Project	IEEE 802.16 Broadband Wireless Access Working Group http://ieee802.org/16 >				
Title	EAPAuth FSM				
Date Submitted	2006-09-22				
Source(s)	Avishay Shraga_ vo	oice: +972-3-920-5763

Single EAP Authentication FSM

[Please add the following text as new clause number 7.2.2.X in 802.16e-2005]

7.2.2.X Authentication state machine

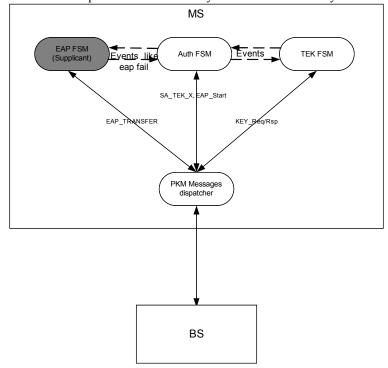
The relationships between the security related FSMs in the system is as described in the diagram:

Figure XXX – Authentication State Machine for single EAP

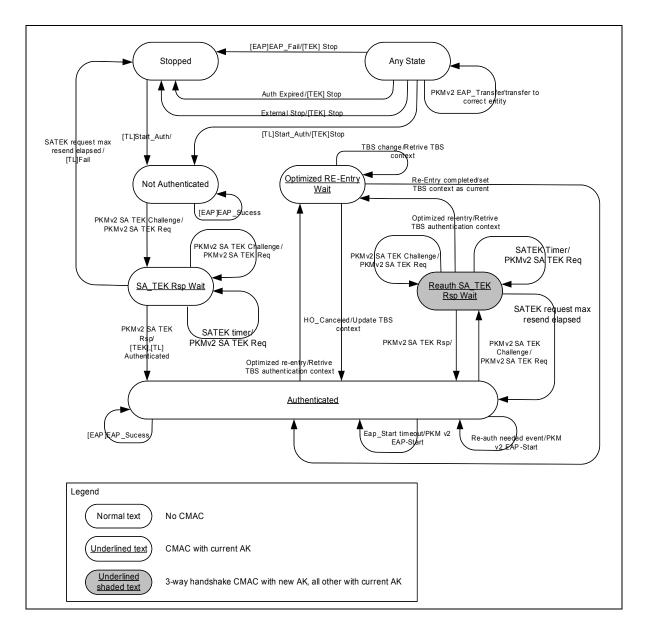
The Authentication state machine for single EAP authentication consists of six states and sixteen events (including receipt of messages and events from other FSMs) that may trigger state transitions. The Authentication state machine is presented in both a state flow diagram (Figure XXX) and a state transition matrix (Table XXX). The state transition matrix shall be used as the definitive specification of protocol actions associated with each state transition.

Through operation of a Authentication state machine, the MS attempts to get authenticated with the NW, maintain this authentication and support Authentication context switching for HO and Idle situations. The state machine takes care of getting authenticated with the NW, ensuring re-authentication will occur before authentication expires and support key derivations according to support optimized re-entry for HO and idle.

The optimized re-entry support is done in a special state in which the NW connection is suspended and therefore re-authentication can't occur, the triggers for re-authentication continue to work in this state but the initiation is done only after returning to an authenticated state.
